RE: **PUBLIC** Reply Comments of the Minnesota Department of Commerce
Docket No. E002/M-25-142

In the Matter of Xcel Energy's 2025 Integrated Distribution Plan.

Figure 4: Histogram of Xcel Substation Transformer Capacity Utilization

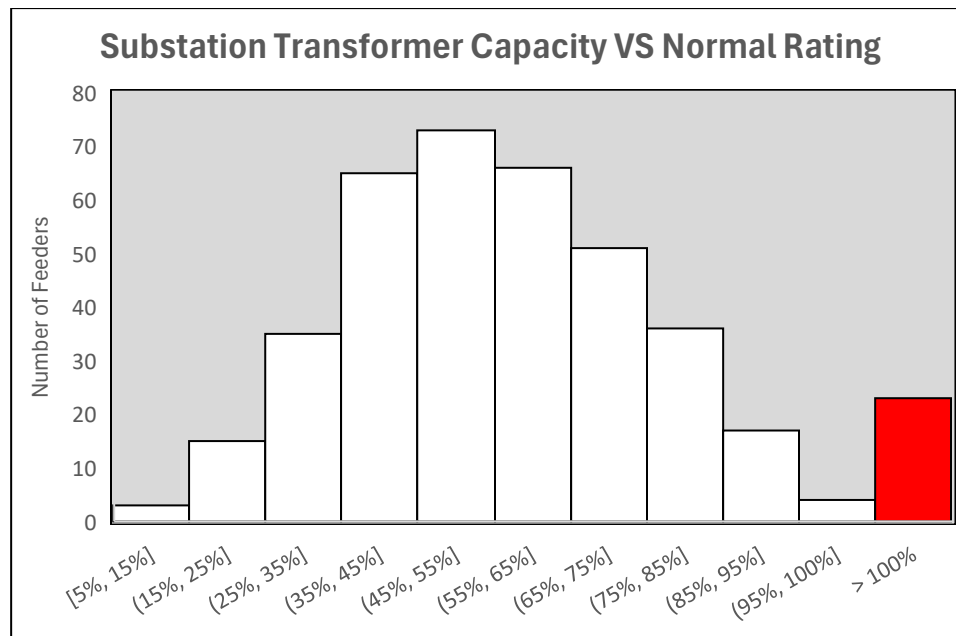
In its initial comments, the Department presented data about capacity overloads for Xcel’s feeders. The Department did not present capacity data for Xcel’s substation transformers, which is shown in Figure 4. Xcel’s median substation transformer capacity utilization is 58.4 percent. Similar to the feeder utilization data presented in the Department’s initial comments,⁸⁹ the transformer capacity data in Figure 4 shows that Xcel exceeds its standard equipment ratings, which furthers the Department’s recommendation that a discussion regarding how these decisions are made and how tradeoffs regarding risk and cost are factored into its capacity budgeting process is warranted.
